DESIGN REVIEW AND PRESERVATION BOARD
SACRAMENTO, CALIFORNIA

ITEM NO. 7
September 16, 1998

PB98-043

Review of a proposed 10 unit single-family detached residential development.

1. SOUTH ELEVATION (F STREET)
A5 1/8" = 1'-0"

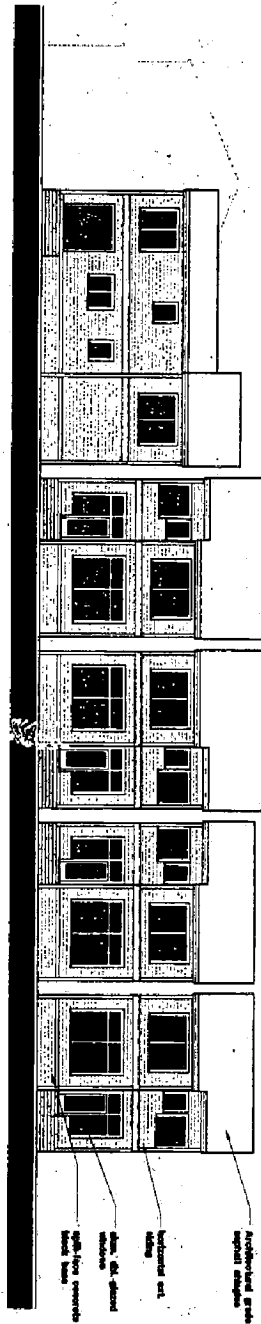
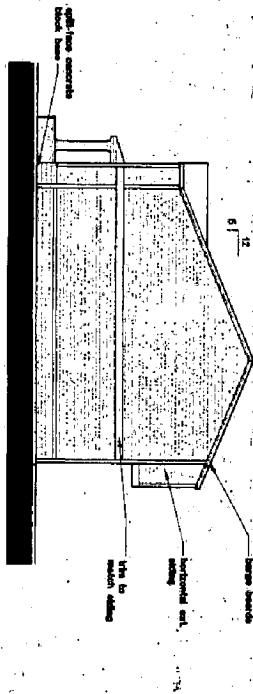
- b. It would be beneficial to add windows to the south side of unit 10A to avoid a blank wall effect at the alley. The added mass of the large gable end above this wall would add further to the negative visual impact of a windowless facade visible to 13th Street.

PRELIMINARY LANDSCAPE PLAN
 1/10" = 1'-0"

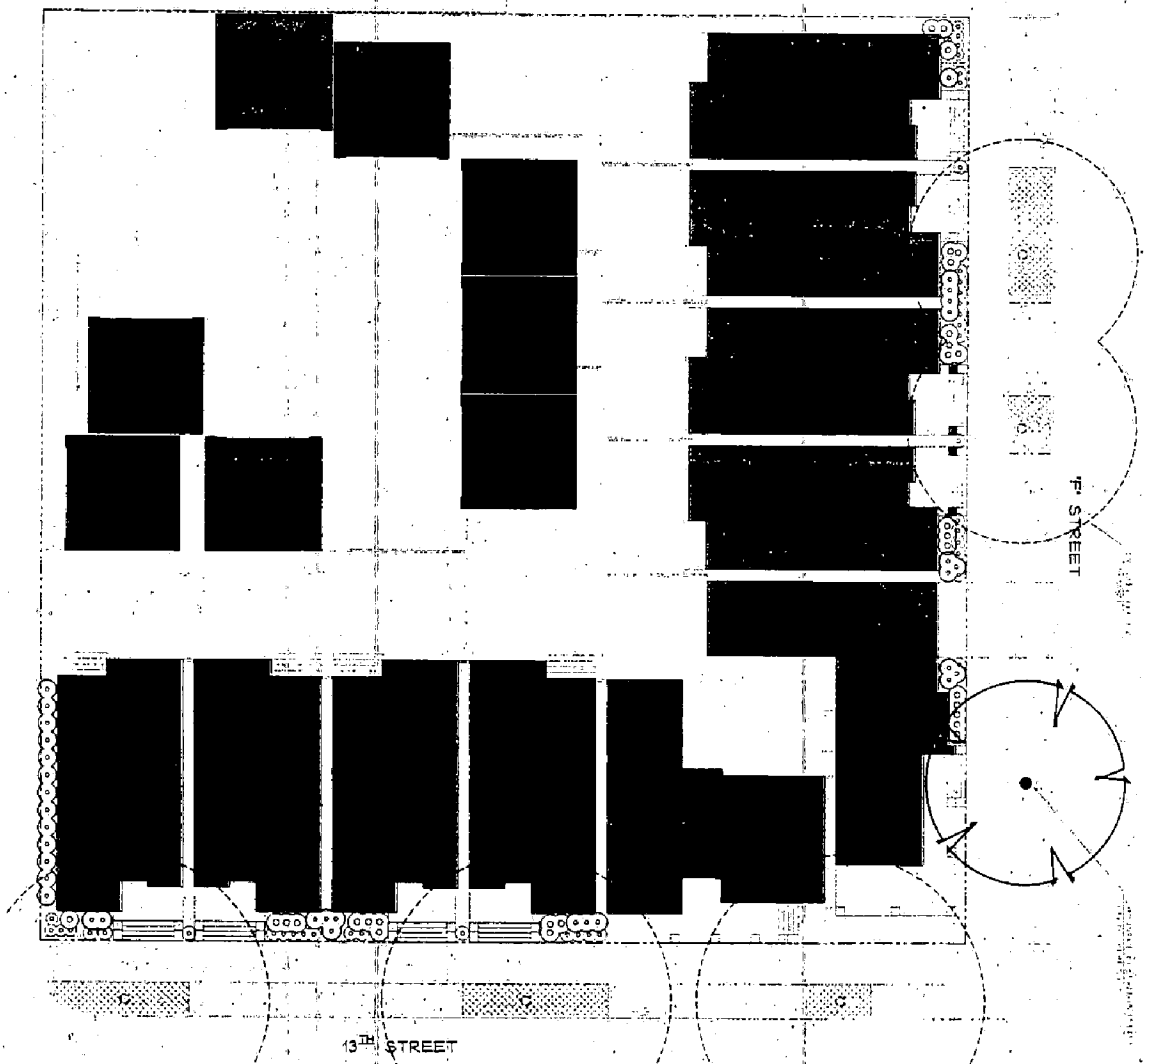
The Board may wish to consider commenting on treatments to enhance the alley/drive/garage area. In the initial staff comments faxed to the applicant a suggestion was made to provide landscaping to enhance alley/garage areas, using available locations and short sections along walls for shrubs/vines. In response, the applicant indicates a willingness to provide enhanced hardscape to these areas; but not landscaping. The fact that there is no common area involved in the proposed project was indicated as a factor that precludes the provision of landscape enhancements. Staff, however, would suggest that the guideline specifically referring to the design of parking areas, and the overall desirability of landscaping in the urban environment and the significance of alleyways as part of that urban environment identified in various adopted City plans, justify landscape consideration beyond what is proposed along the street frontages and within the private spaces of the individual units. Recognizing that a cold water supply is likely to be provided to the rear yard of each property, the further extension of these lines would be appropriate not only for the irrigation of the suggested landscape areas but also for other uses in and around the garages such as an occasional carwash, etc.

provide landscaping to enhance alley/garage area, using available locations and short sections along walls for shrubs/vines.
